267 O'Connor Street

## SDRP REPORT (07/02/2025)

**267 O'Connor St.** | Formal Review | Official Plan Amendment & Zoning By-law Amendment Application | Taggart Realty Management, Hobin Architecture, UNStudio

*Figure 2. The Pinnacle on John Street, Toronto, which has a sloped façade above a triangular-shaped POPS.*

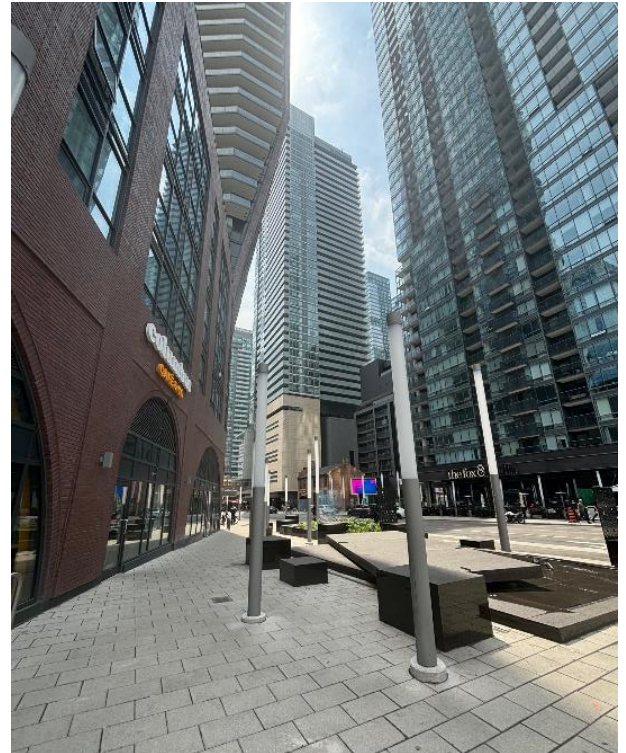
- The Panel has concerns with the large, tower cantilever which in their view negatively affects the POPS and public realm. The Panel recommends softening the cantilever as much as possible, potentially by sloping/tapering it considerably over several floors or increasing the height of the cantilever to at least 6 or 7-storeys above the POPS. The Panel provided a few examples in Toronto, such as the Pinnacle on John Street and 8 Cumberland Street, which are pictured below for reference.
